MIL/6026/4-X - LAND ADJACENT TO THE APPLECART, MILTON HEIGHTS.

Proposal: Demolish existing buildings. Erection of new buildings to form trunk road

Location: Land adjacent to the Applecart, Milton Heights, Milton, Abingdon.

Application No.: MIL/6026/4-X

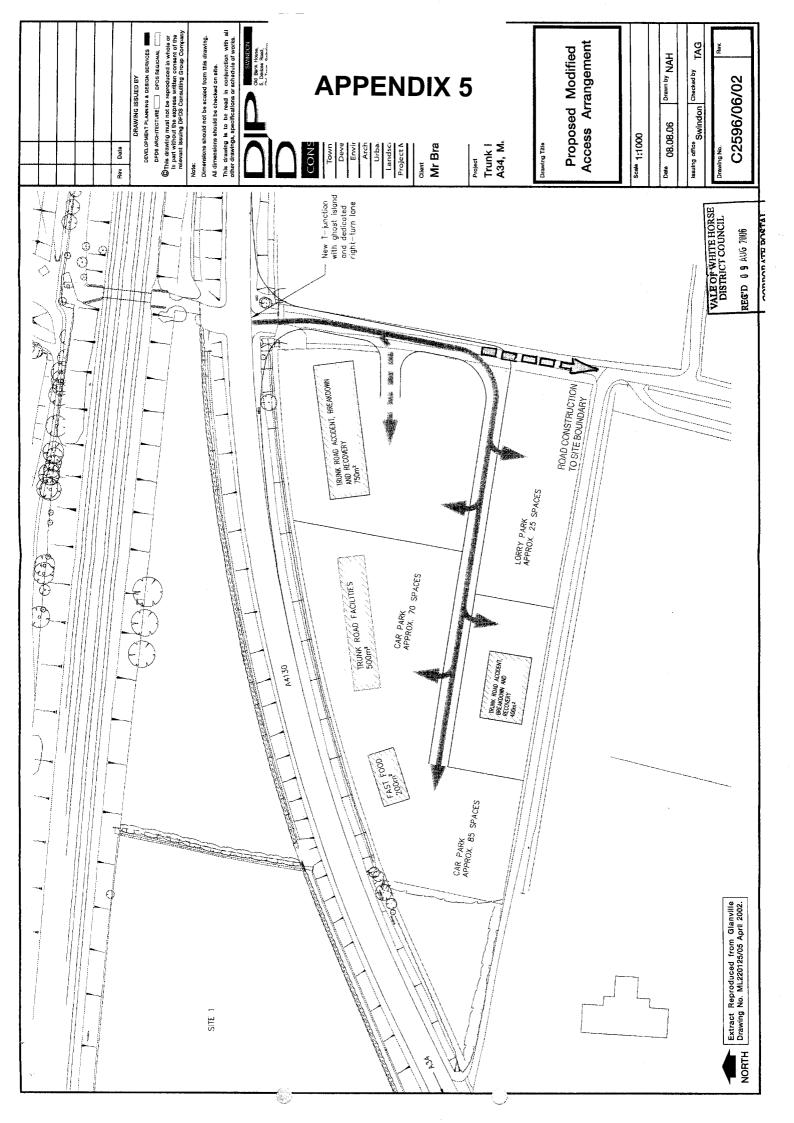
Finally, given the growth of traffic over time and the addition of traffic generated by other significant developments in the Didcot area, the Highway Authority consider it necessary to secure sufficient land to allow the delivery of a 'long term' access strategy (phase 3). Such works would maintain the signalisation of the junction but would require the widening of the junction to two lanes on both A4130 approaches to allow additional capacity.
